UNITED NUCLEAR CORPORATION, HEMATITE-LICENSE AMENDMENT-
DOCKET 70-36, DATED JUNE 7, 1953

The applicant requests a license amendment to manufacture 20 weight percent enriched $\text{UO}_2 \text{SO}_4 \cdot \text{D}_2\text{O}$. The $\text{UO}_2 \text{SO}_4$ has been produced in the high enrichment area (Red Box) of the applicant's plant.

License amendment to use D_2O for the manufacture of 20% enriched $UO_2SO_4 \cdot 3D_2O$

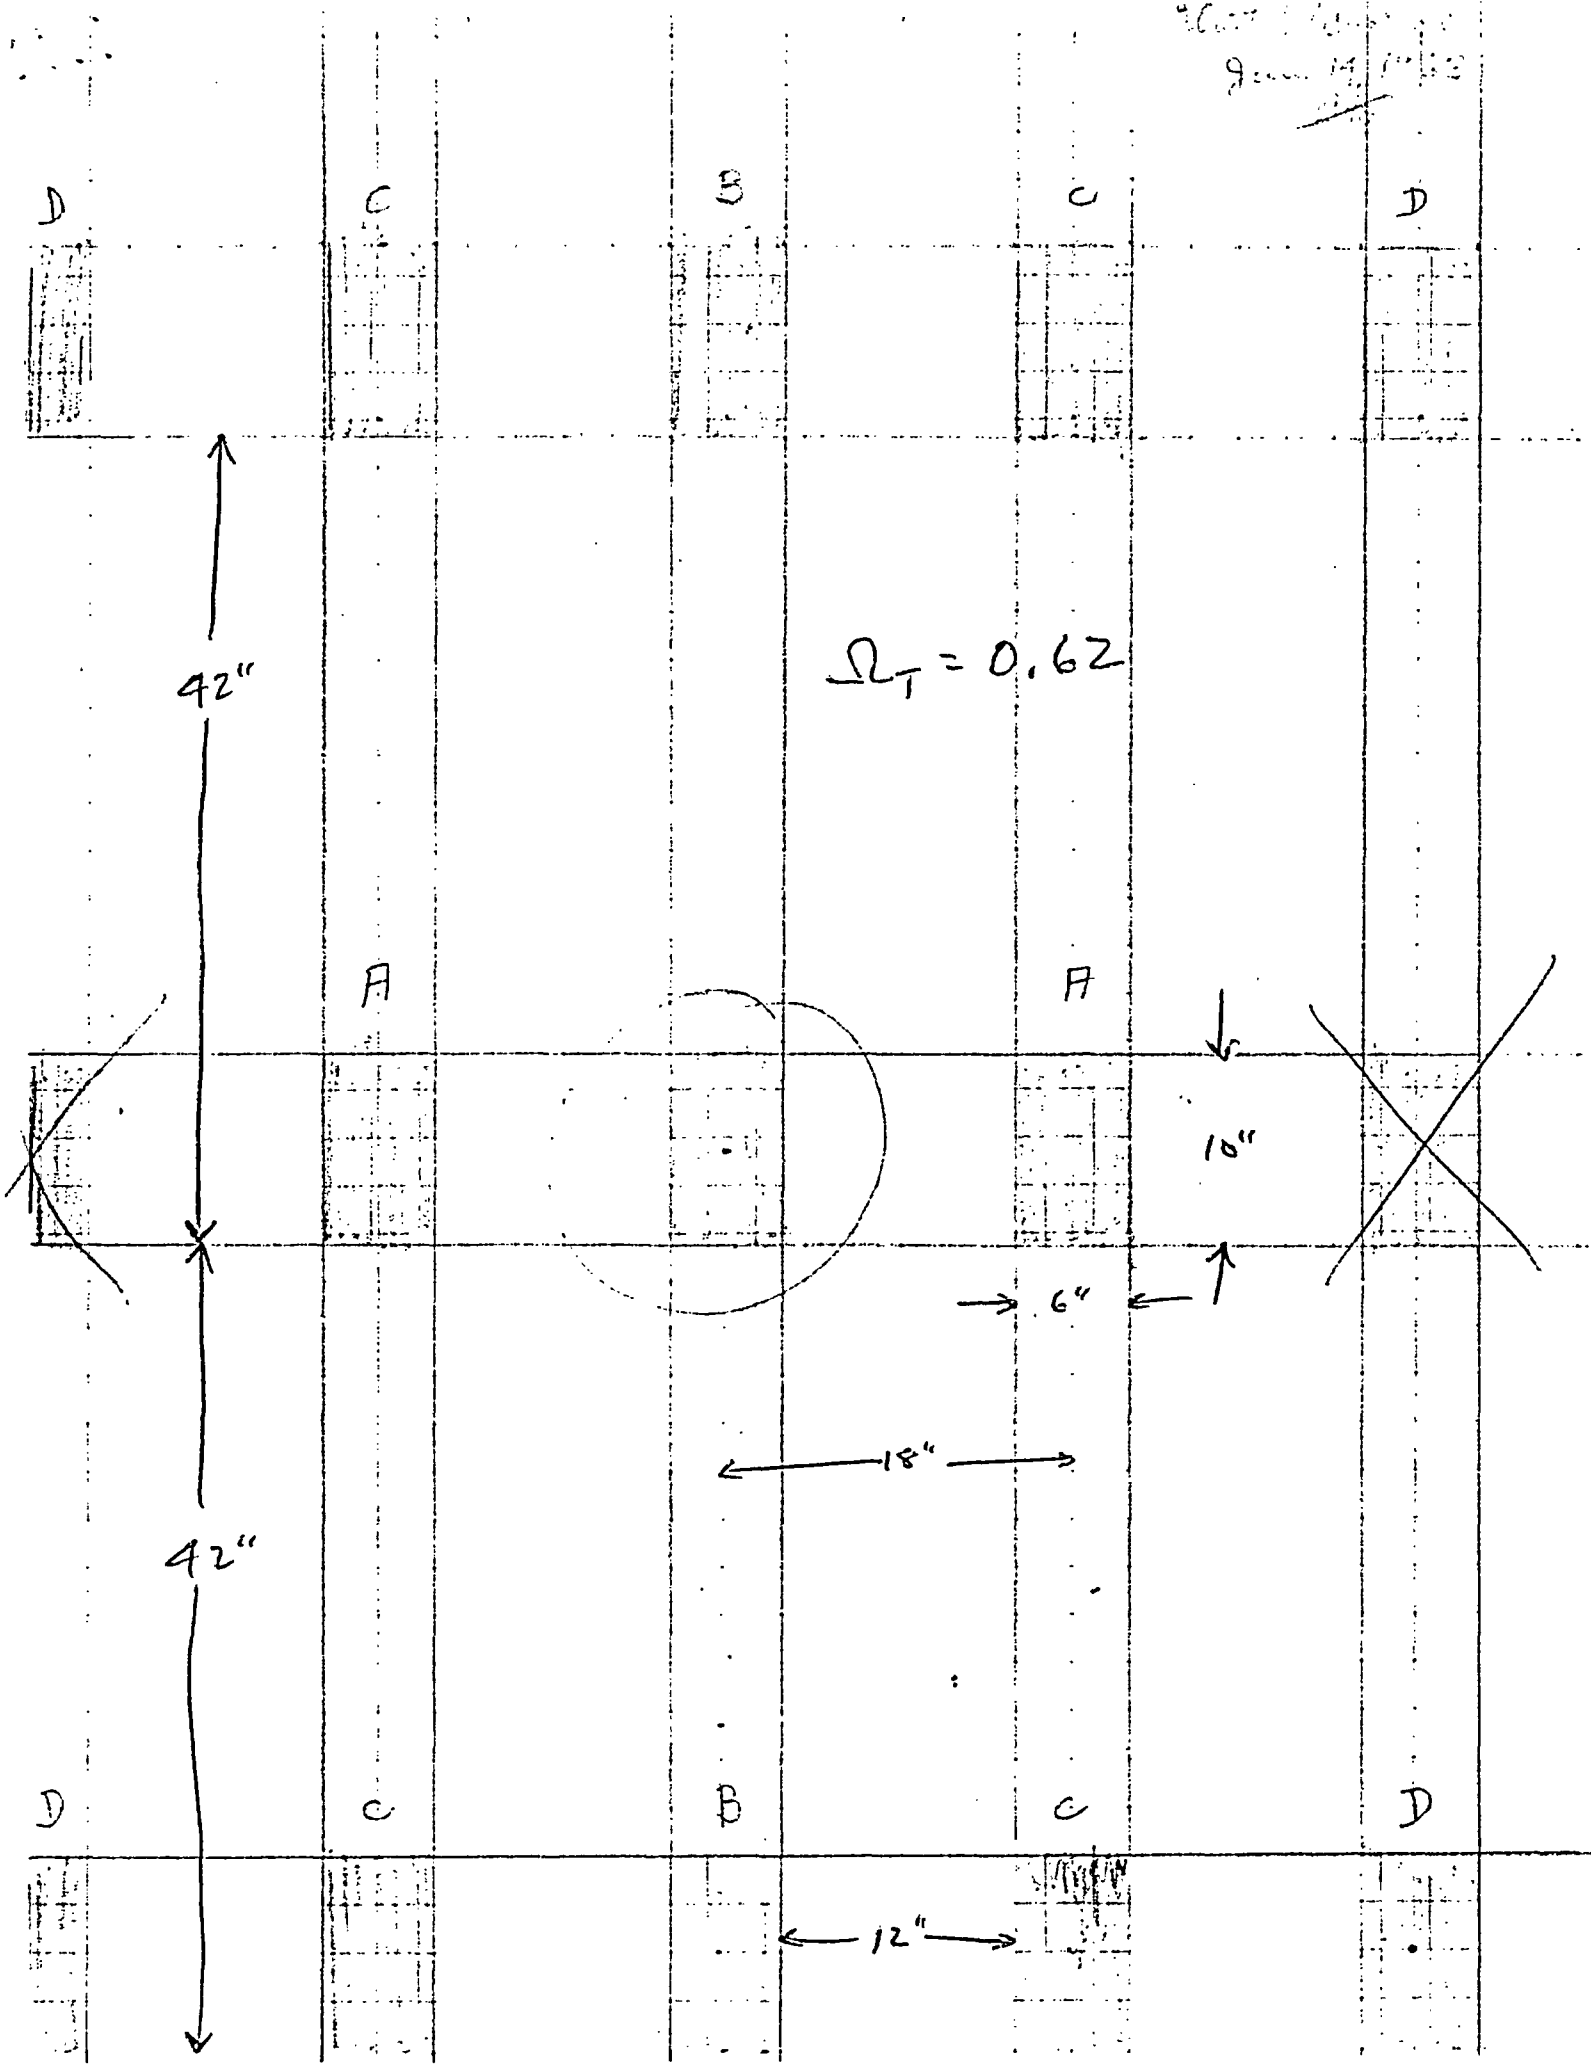
We have confirmed the nuclear safety of the applicant's storage array as shown in Figure 1. The applicant has proposed to store in safe mass, quantities, and, therefore, assumed a multiplication factor of 0.65 for each unit. The solid angle subtended in the central storage bottle is much less than the permissible 2.5 steradians for this value of the multiplication factor.

The applicant should confirm that this storage array will be isolated from all other special nuclear material (licensed and contract) as given in Part 70.57 or submit a nuclear safety analysis to demonstrate the array is safe even though it is not isolated.

$$\Omega = \frac{DL}{h \sqrt{h^2 + L^2}}$$

containers 6" dia. by 10" height

2A	=	0.507
2B	=	0.086
4C	=	0.014
4D	=	0.009
		<u>0.616</u>

$$\Omega_T = 0.62$$
